NAVIGATOR QUARTER, LAND ADJACENT TO SOUTHAMPTON AIRPORT

PLANNING AND DESIGN ADDENDUM

HYBRID PLANNING APPLICATION

Planning & Design Statement Addendum

Figure 2. Extract of the Revised Parameters Plan showing North Plot.

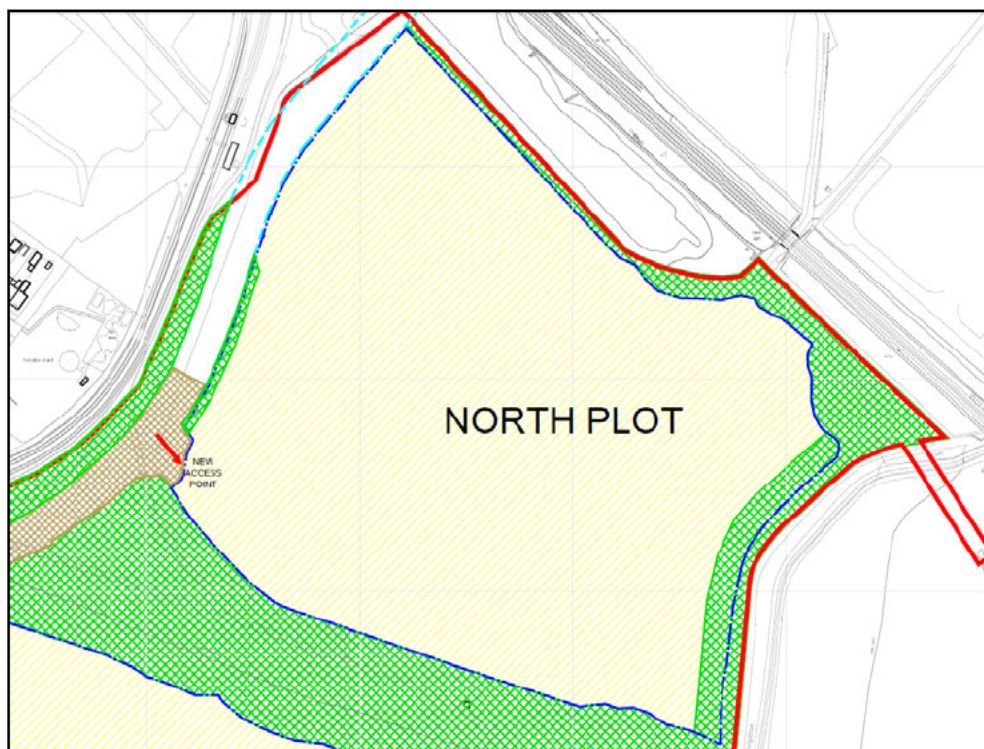
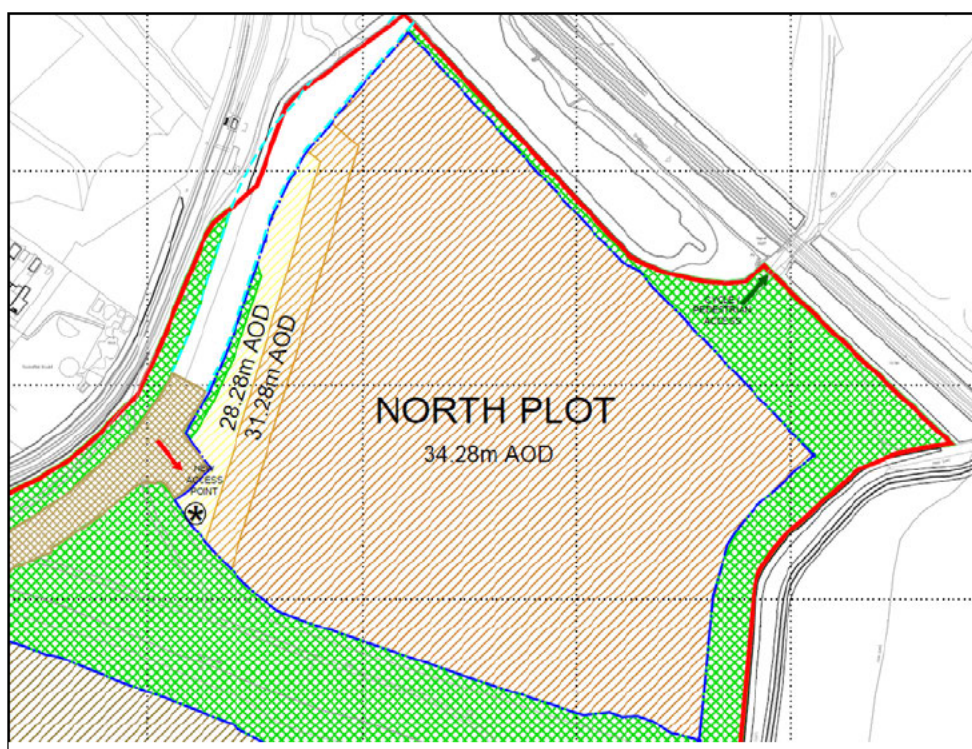
- 3.3 Next to the western boundary of the North Plot is Campbell Road, a residential street with an associated play area. After review of the scheme, the Urban Design Officer concluded that when viewed from the playground off Campbell Road, if built at their maximum proposed height parameters, the units would be too visible and dominant.

- 3.4 On the updated Parameters Plan (ref. NQ-MSA-SI-XX-SDR-A-2001 PL06) two new zones have been created next to the site's boundary with the play area, where potential maximum building heights have been reduced from 35.95m AOD to 28.28m AOD and 31.28m AOD (see figure 2 below).

Figure 4. Extract of the Revised Parameters Plan showing South Plot.

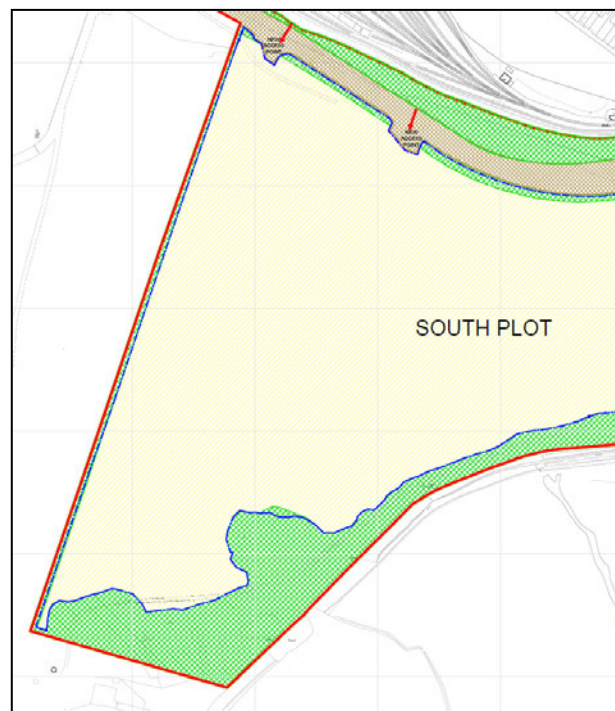
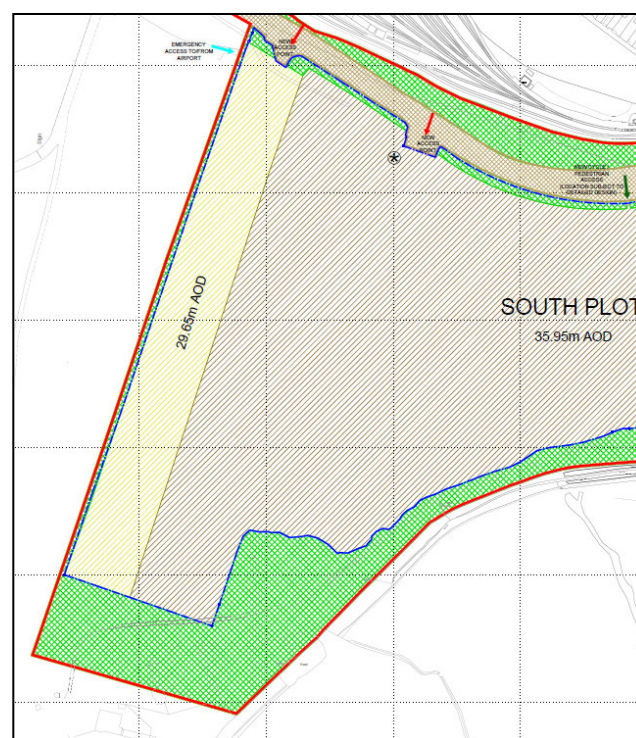
- 3.6 The Urban Design Officer also raised concern that along the western boundary of the South Plot, where the site is overlapped by the Airport Public Safety Zone, building heights are '*fairly high*'. On the updated Parameters Plan, a new zone has therefore been created next to the western boundary of the South Plot, where maximum building heights have been reduced from 35.95m AOD to 29.65m AOD.

Figure 5. Extract of Parameters Plan showing Emergency Access via Southampton Airport into the South Plot.

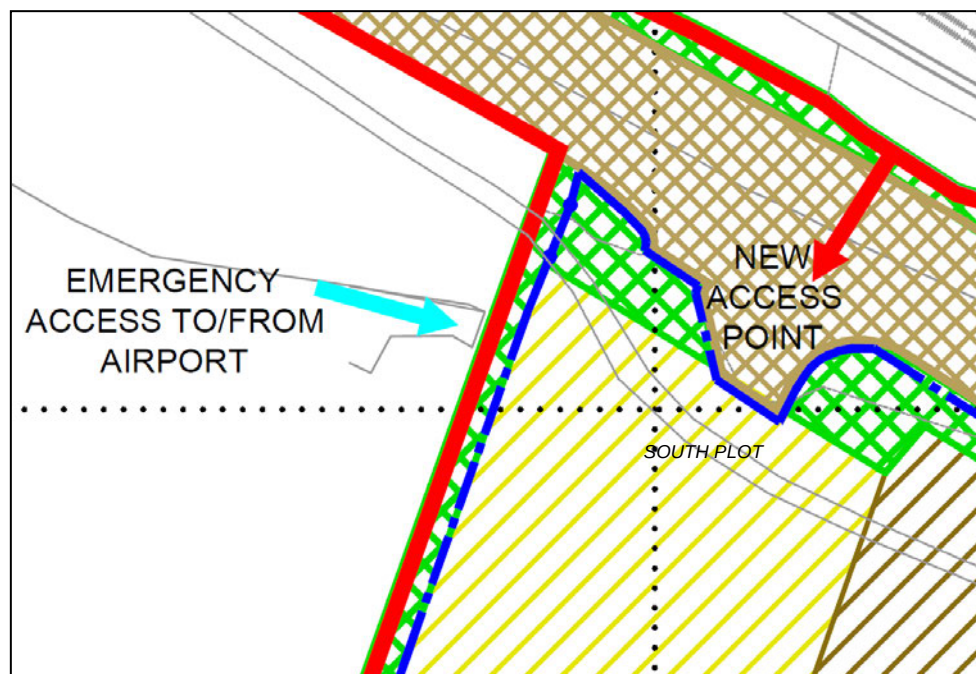
3.34 In respect of emergency access, MSA submitted a Note (dated November 2025) detailing the secondary means of emergency access, via Southampton Airport, in the event that use of Mitchell Way is impeded. This emergency access point is now identified on the updated Parameters Plan submitted with this Addendum (see figure 5). HCC Highway Authority have raised no objection to this proposal, subject to the agreement from emergency services.

Figure 6. Extract of Parameters Plan showing indicative new cycle / pedestrian access to the South Plot.

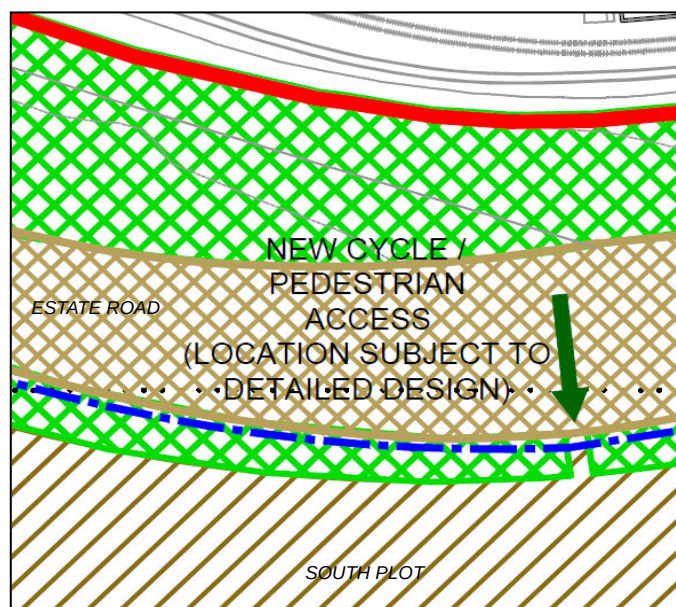
- 3.35 In respect of providing a direct pedestrian link between the North Plot and South Plot, this has been considered and cannot be provided through the central tree belt because of the significant arboricultural and ecological impacts this cut-through would result in. Any route would require substantial earthworks, surfacing treatment and lighting, which would be against the objective to retain as much existing habitat as possible to ensure connectivity with the surrounding area.

- 3.37 The exact alignment of this route is subject to detailed design, and the objective of creating such a route is set out on the amended parameters plan as reproduced in Figure 6 below)

Figure 7. Extract of Illustrative Site Layout Plan showing an Acoustic Fence between the estate road and the dwellings at Campbell Road (shown by dashed orange line).

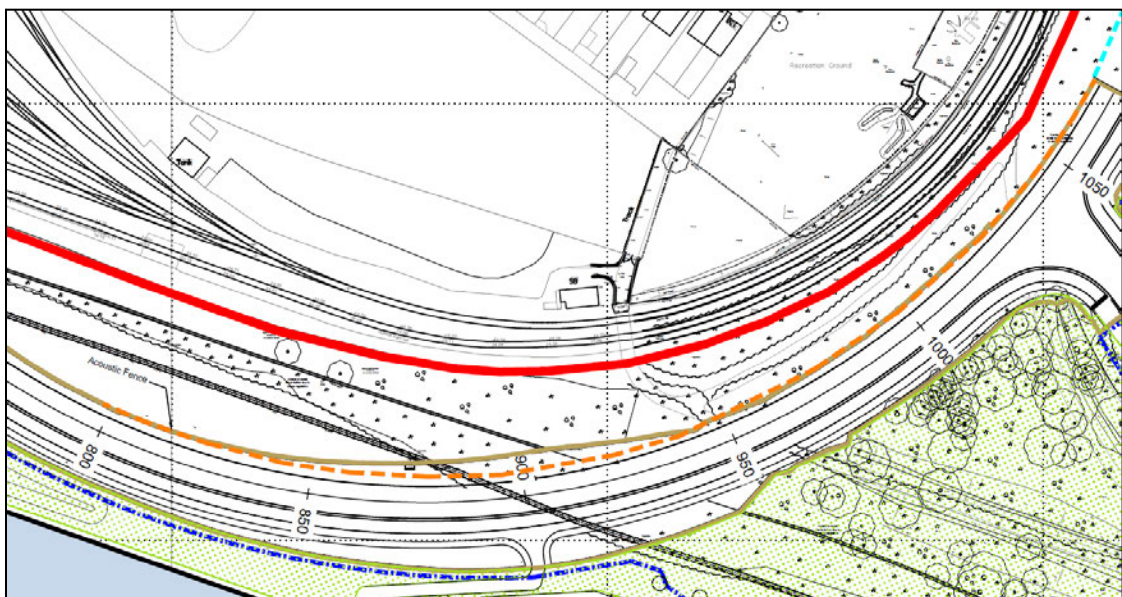
- 3.53 Following these comments, updated Noise Surveys were prepared and sent to the Council. The Surveys were reviewed by the Environmental Health Officer, and in relation to projected noise from traffic, the office requested that more robust mitigation measures be implemented.

- 3.54 The applicant's Acoustician has assessed the provision of a 2.5m acoustic fence along the site boundary closest to Campbell Road. The further assessment demonstrates that with this fence in place, noise levels from the site during both daytime and night-time will comply with desirable noise standards and so adverse impacts are unlikely. These details, including diagrams showing the effectiveness of the acoustic barrier on preserving residential amenity, were issued to the Council in January 2026. Later that month, the Environmental Health Officer confirmed that they had no further comments.

- 3.55 The acoustic barrier is also shown on the updated Illustrative Site Layout Plans provided with this addendum (see figure 7).

APPENDIX 4. Notional design for future Chickenhall Lane Link Road connection

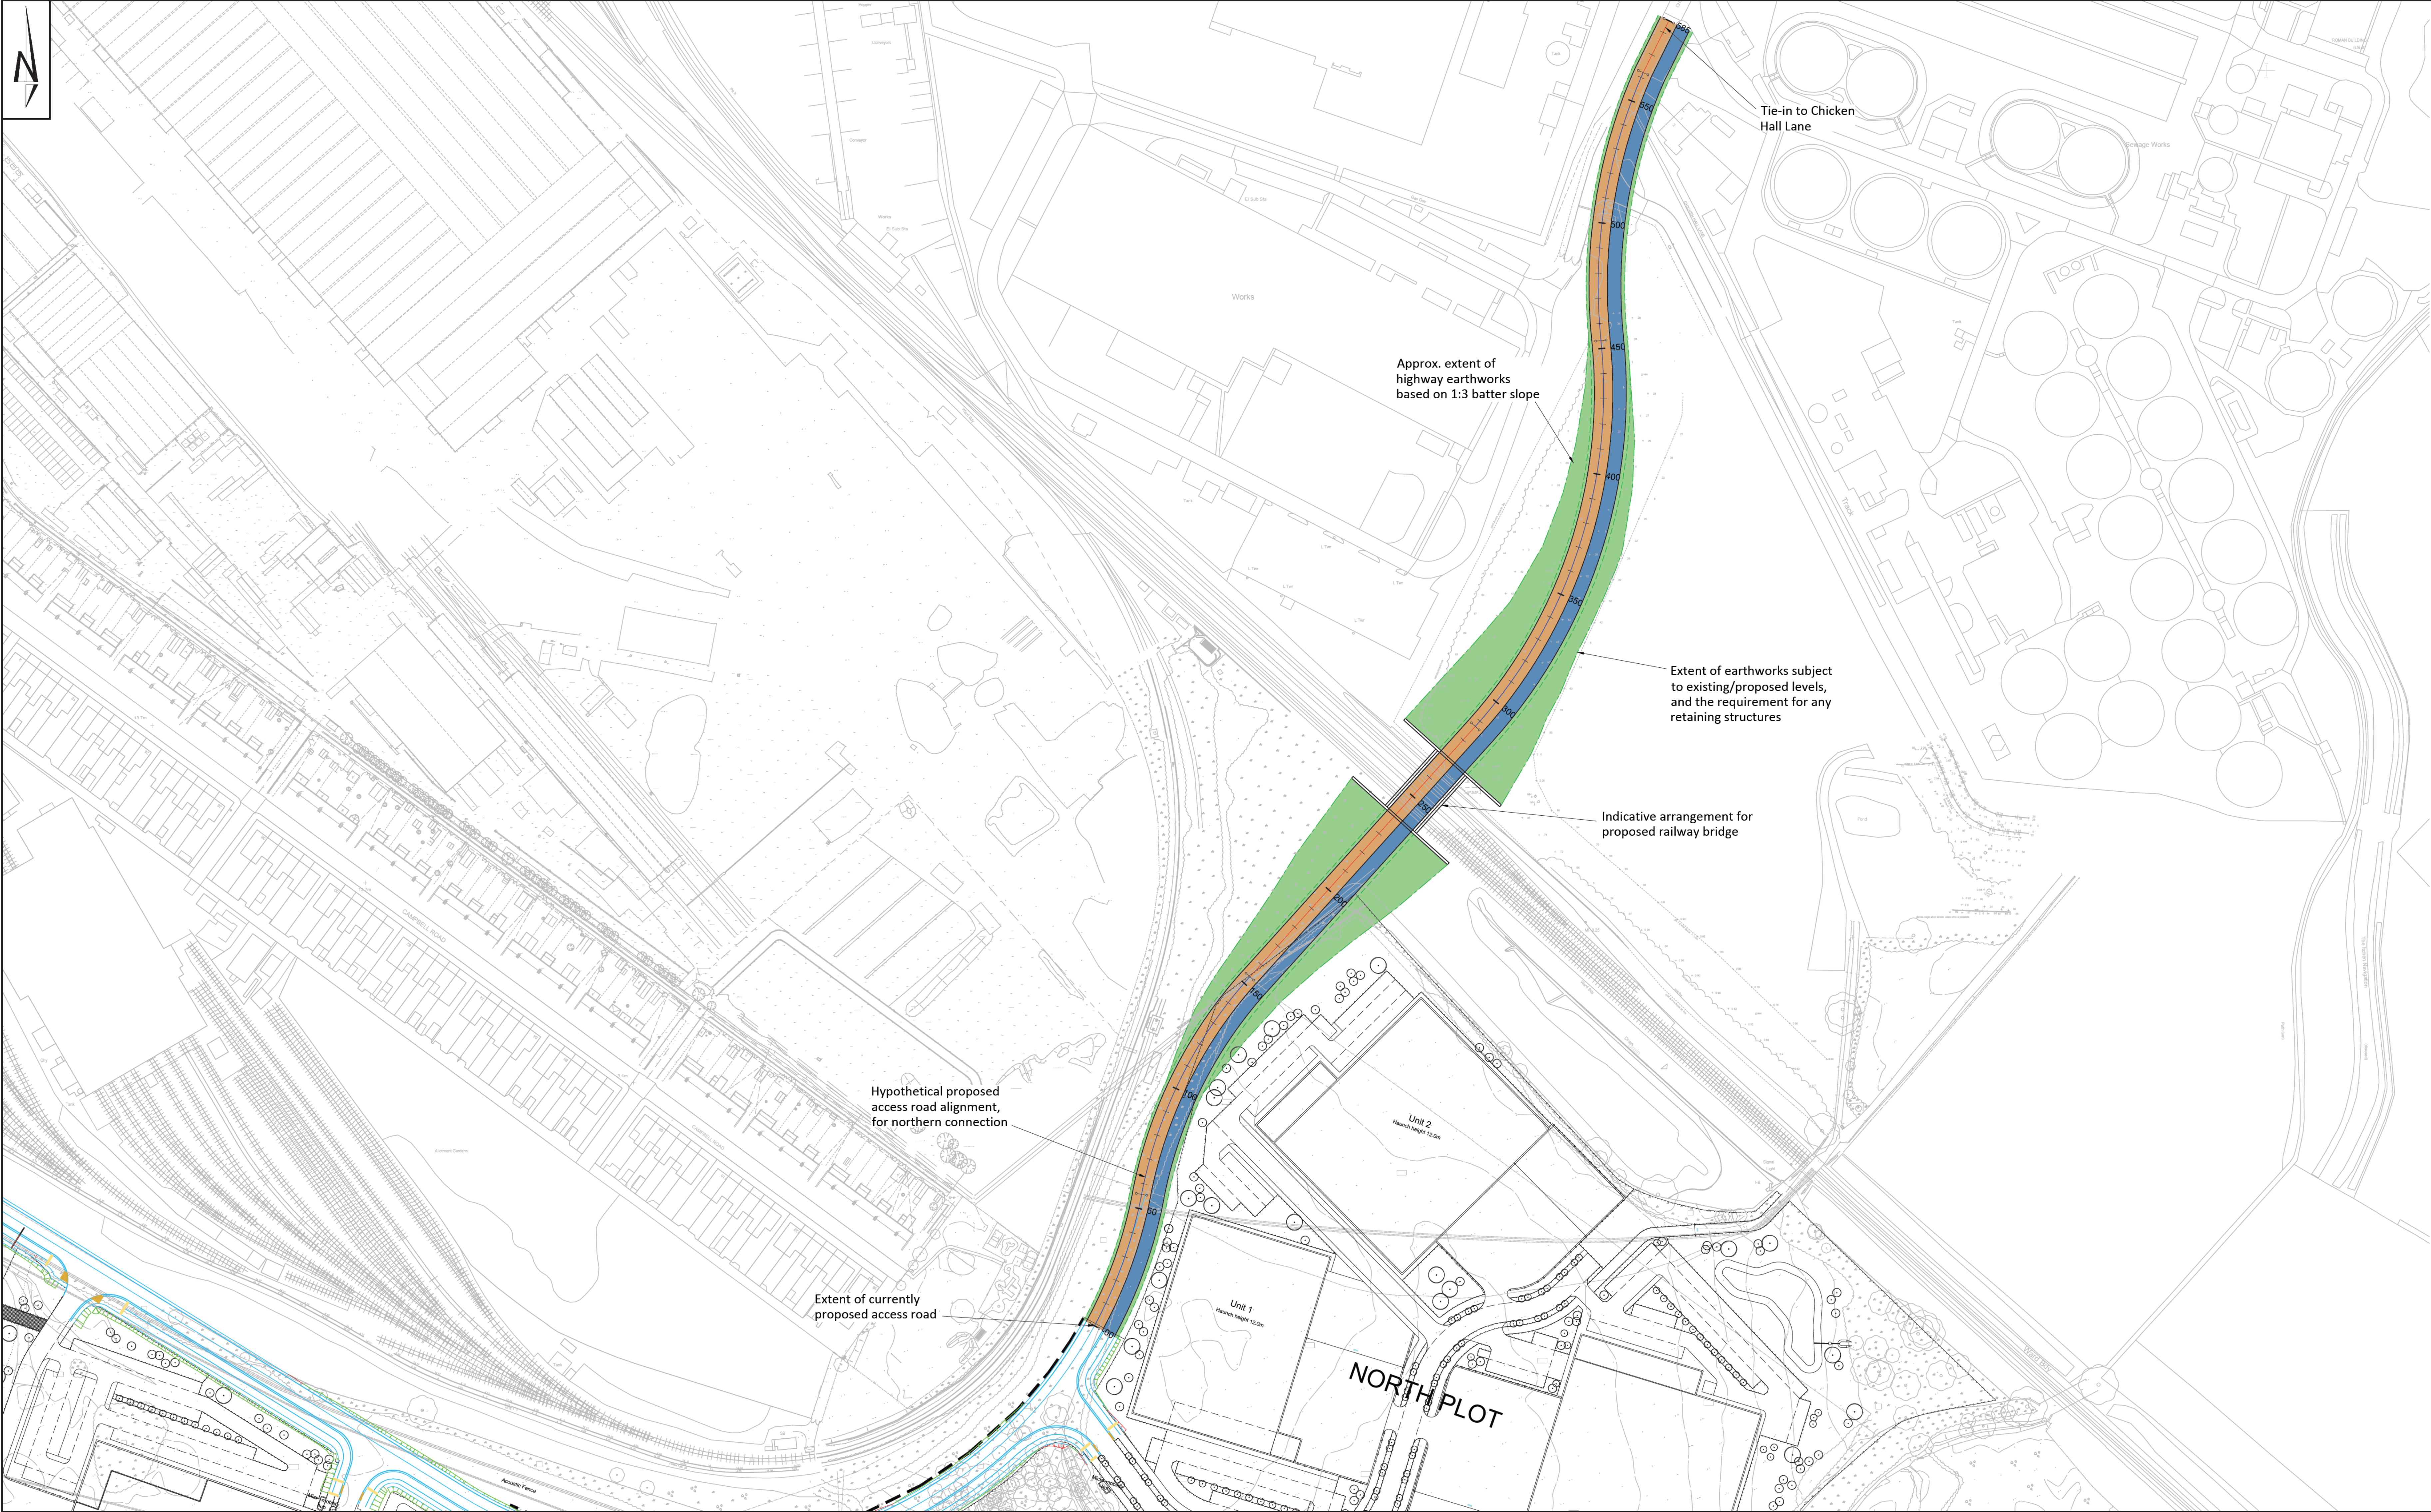
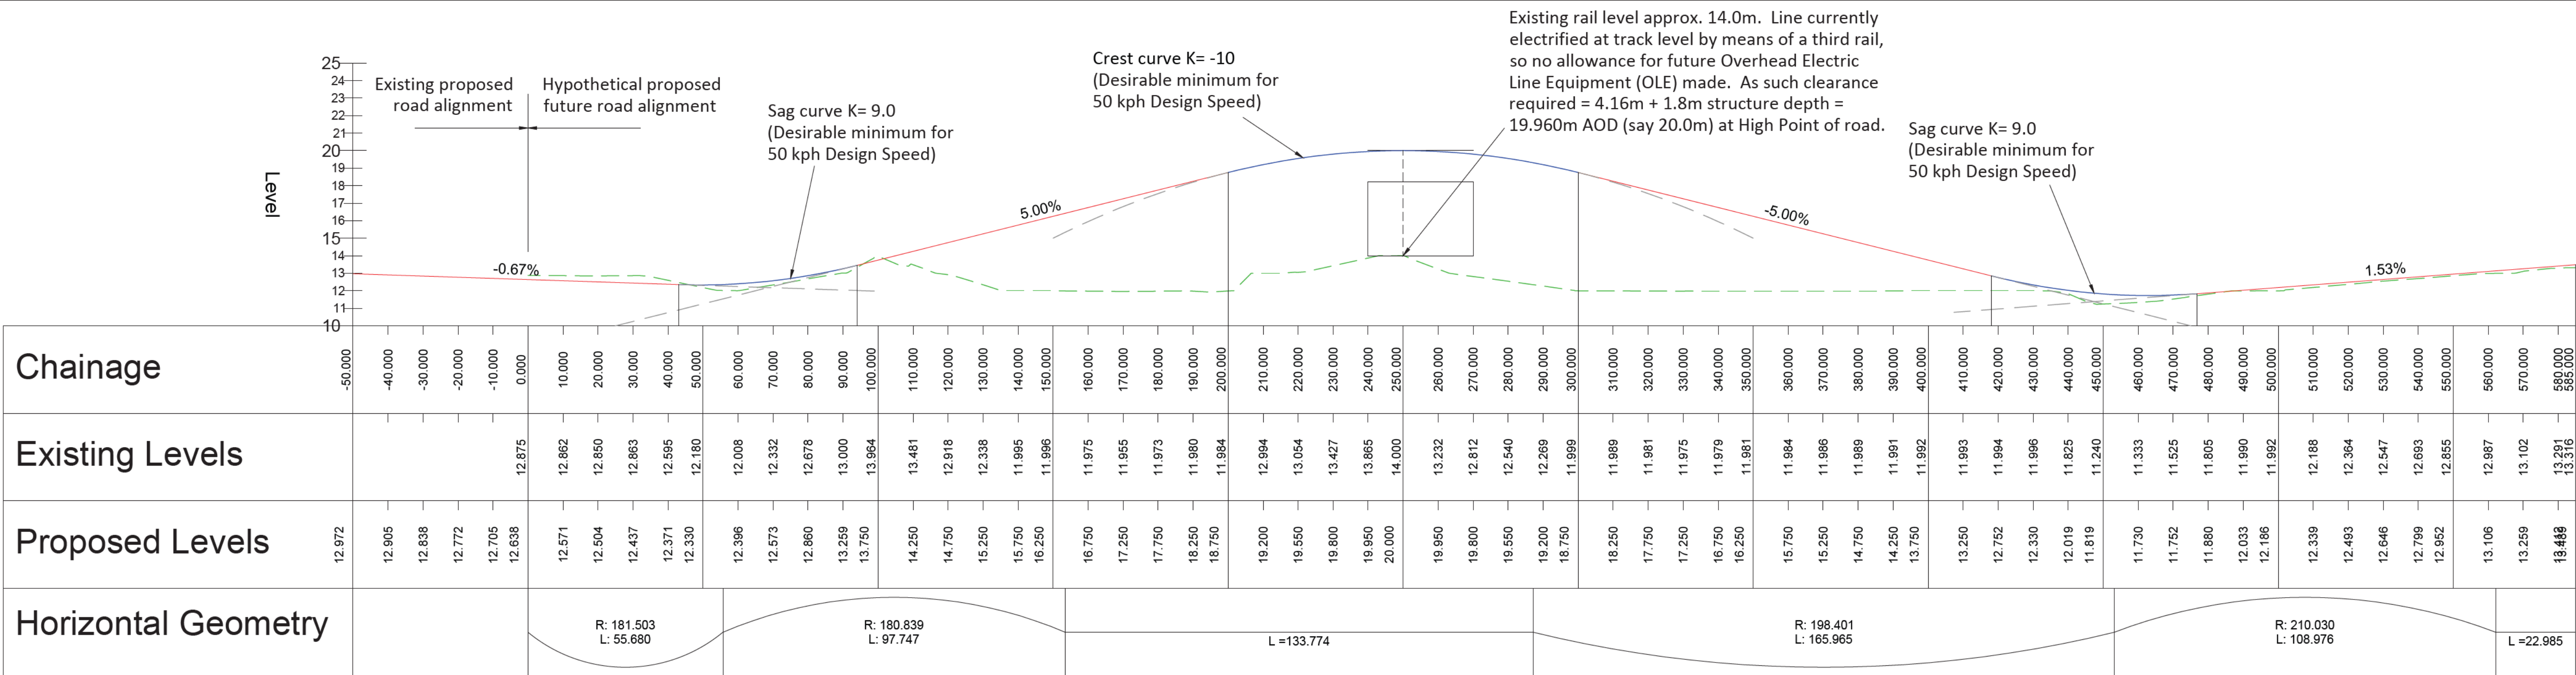
The design and layout of new development shall not preclude but shall make allowances for the provision of a new Chickenhall Lane link road

3.42 A notional design has been prepared to show how the Chickenhall Lane Link Road could come forward at a later stage (included at Appendix 4 of this Addendum). Therefore, if it is later determined that the Link Road is likely to proceed, then the design and layout of the proposals set out in this application do not preclude this from happening.
